**TECHNICAL EVALUATION REPORT
CHRISTENSEN RANCH MINE UNITS 2 THROUGH 6 RESTORATION REPORT
URANIUM ONE USA, INC., WILLOW CREEK ISR FACILITY**

DATE: October 23, 2012
DOCKET NO.: 040-08502
LICENSEE: Uranium One USA, Inc.
SITE: Willow Creek Christensen Ranch, Wyoming
PROJECT MANAGER: Ron C. Linton
TECHNICAL REVIEWERS: John L. Saxton, Elise A. Striz

Figure 3c. MU2 North and South Radium-226 Stability Monitoring Trend Analysis

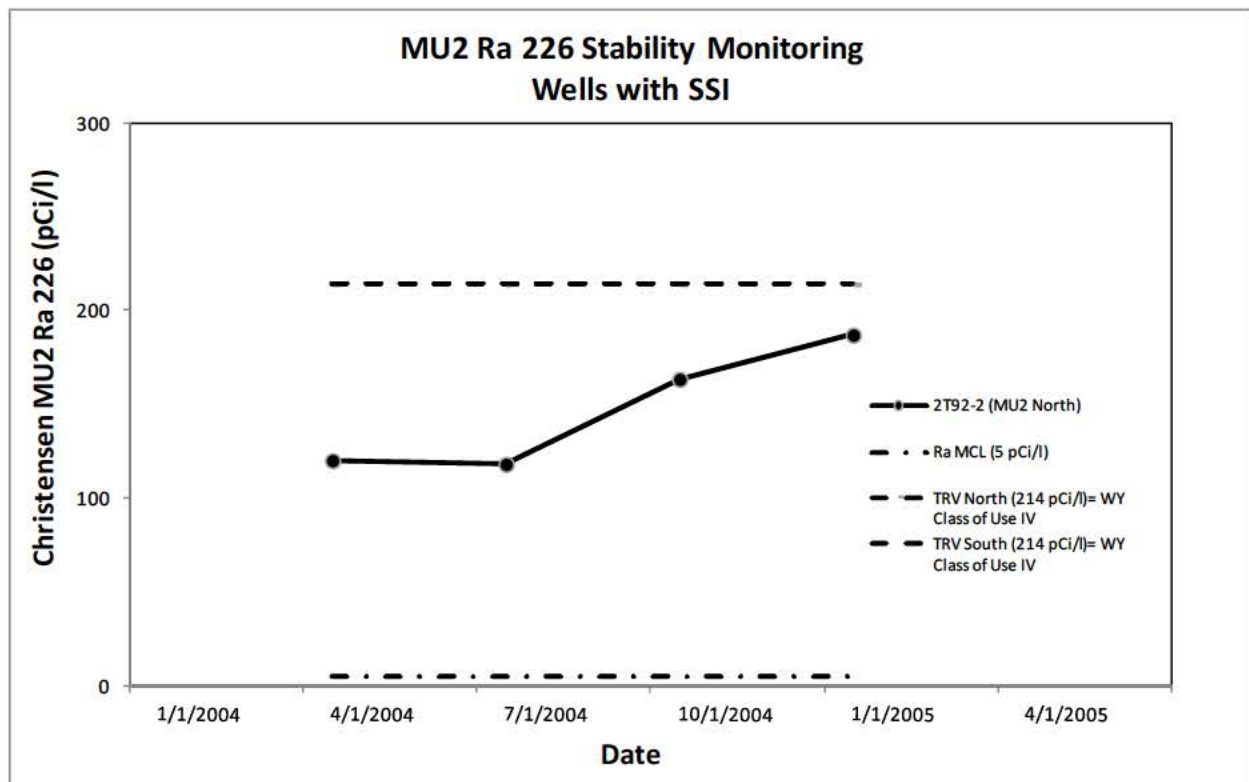
The SSI trend for Mine Unit 2 South for uranium in this well is shown in Figure 3c. It is of concern to the staff because it shows that uranium in this well is above the Class IV standard (background TRV) and is increasing.

- (1) Demonstrate that the SSI trends for uranium and radium-226 at well 2T92-2 are reversed and stable.
- (2) Provide a confirmatory analysis of the groundwater quality at well 2MW108 subsequent to the corrective actions for the 2011 excursion that demonstrates impacts to the aquifer following the 2011 excursion event meet regulatory requirements (groundwater protection criteria).
